## Considerations for the Design of Precast Concrete Bearing Wall Buildings to Withstand Abnormal Loads\*

by PCI Committee on Precast Concrete Bearing Wall Buildings

Comments by Emil C. Hach, William Hanuschak, Alan H. Mattock and Committee

Fig. A. Shear strength of smooth concrete joints.

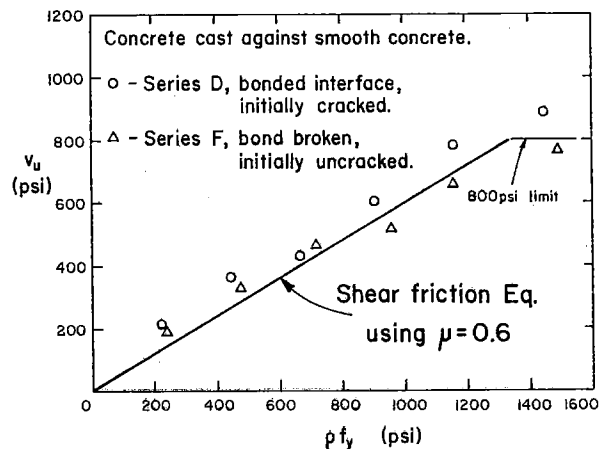
Tests recently made at the University of Washington of shear transfer across a concrete to concrete smooth interface indicate that the value of  $\mu = 0.7$  is unconservative for this situation. The actual variation of shear transfer strength with amount of shear transfer reinforcement provided is shown in Fig. A. The shear strength is expressed as a nominal shear stress,  $v_u = V_u/(bd)$ ; and the amount of reinforcement is expressed in terms of the reinforcement parameter:

In plotting the data and correlating it with the shear-friction theory, the value of the capacity reduction factor  $\phi$  was taken as 1.0, since all material strengths and specimen dimensions were known exactly. It can be seen that the shear strength of a smooth concrete-to-concrete interface can be predicted closely using the shear-friction equation provided the value of  $\mu$  is taken as 0.60.

It can be seen that the shear strengths obtained for the two interface conditions were very similar and that a value of  $\mu = 0.60$  is appropriate when using the shear-friction theory to calculate the shear strength of a smooth concrete to concrete joint.

The Committee thanks Messrs. Alan H. Mattock, Emil C. Hach and William Hanchak for their comments on these recommendations for precast concrete bearing wall buildings. The Committee appreciates Professor Mattock sharing with us research done on shear friction at the University of Washington. The report will be changed to reflect this recommendation of  $\mu = 0.6$  for smooth concrete interface.
